TYPICAL PAVEMENT MARKINGS AT ENTRANCE RAMPS

LAST REVISION	REVISION	DESCRIPTION:	FY 2023-24 STANDARD PLANS	INTERCHANGE MARKINGS	INDEX	SHEET
11/01/21					711-003	2 of 8

TWO-LANE PARALLEL-TYPE ENTRANCE WITH ADDED LANE
(Single-Lane Parallel-Type Entrance Without Added Lane Similar, See Note 3)

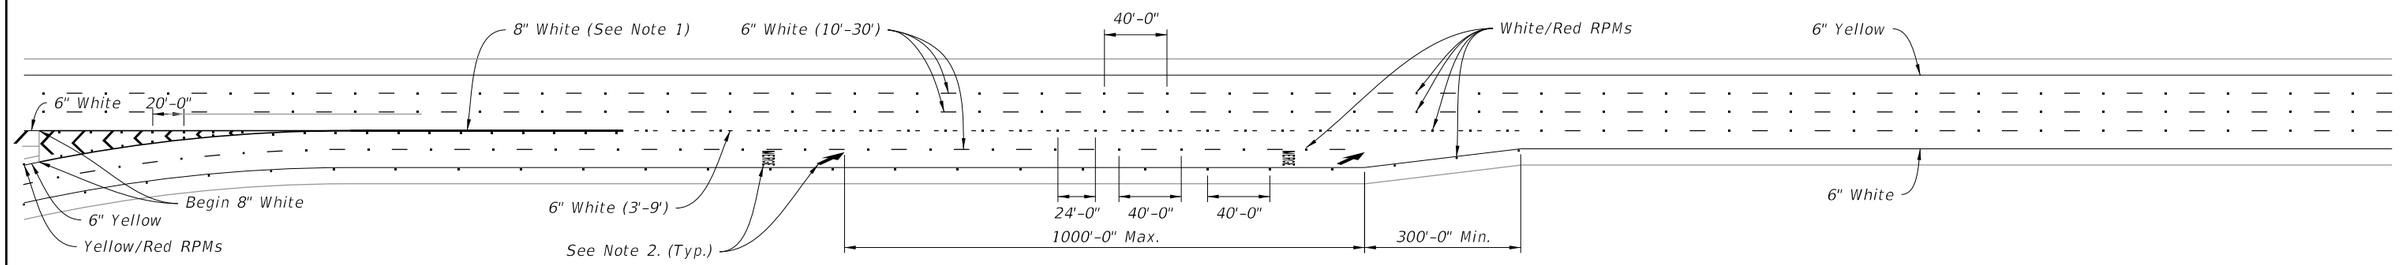
Revised Note to clarify use of dotted interchange line.

1. Extend this 8" white Pavement Marker one-fourth the length of the acceleration lane from the gore markings.
2. See Index 711-001 for pavement message dimensions and details.
3. Discontinue the 6" White (3'–9') Dotted Interchange Line where the merging taper begins for a Single-Lane Parallel-Type Entrance Without Added Lane. Merge Pavement Message and Arrow only used for Two-Lane Entrances.
